Amendments to the Drawings:

REMARKS/ARGUMENTS

Annotated Sheet Showing Changes

FIG. 3a

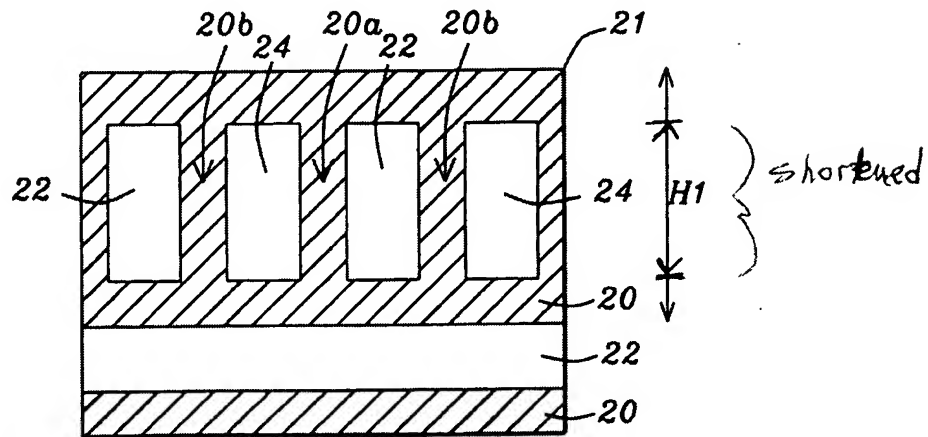
The attached sheets of drawings include changes to FIG. 3a and FIG. 7. The sheet that includes FIGS. 3a, 3b, and 4a replaces the original sheet which includes FIGS. 3a, 3b, and 4a. In FIG. 3a, the length of the double headed arrow H1 has been shortened. The sheet that includes FIG. 7 replaces the original sheet which includes FIG. 7. In FIG. 7, the spelling of "Position" on the x-axis has been corrected.

The drawing in FIG. 3a has been changed to correct the phase height H1 which is defined on page 13, lines 13 -14 as the height of the opening in regions 22 and 24. The drawing in FIG. 7 has been changed to correct the spelling of the word "position".

FIG. 7

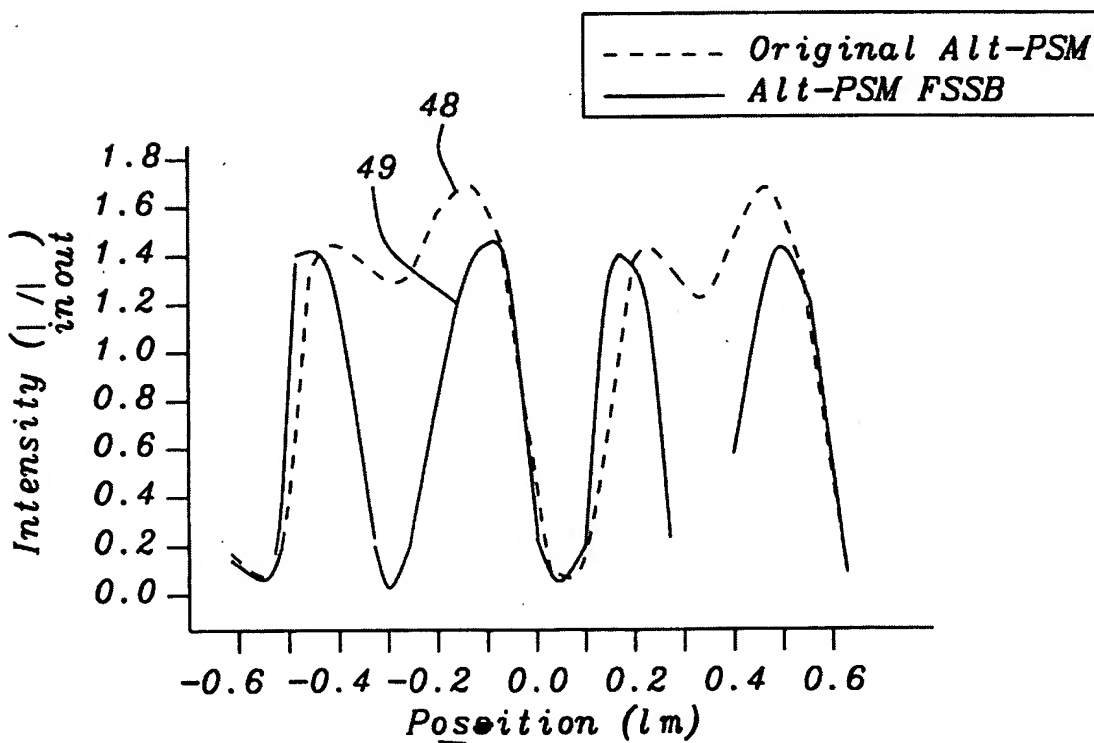
"s" removed
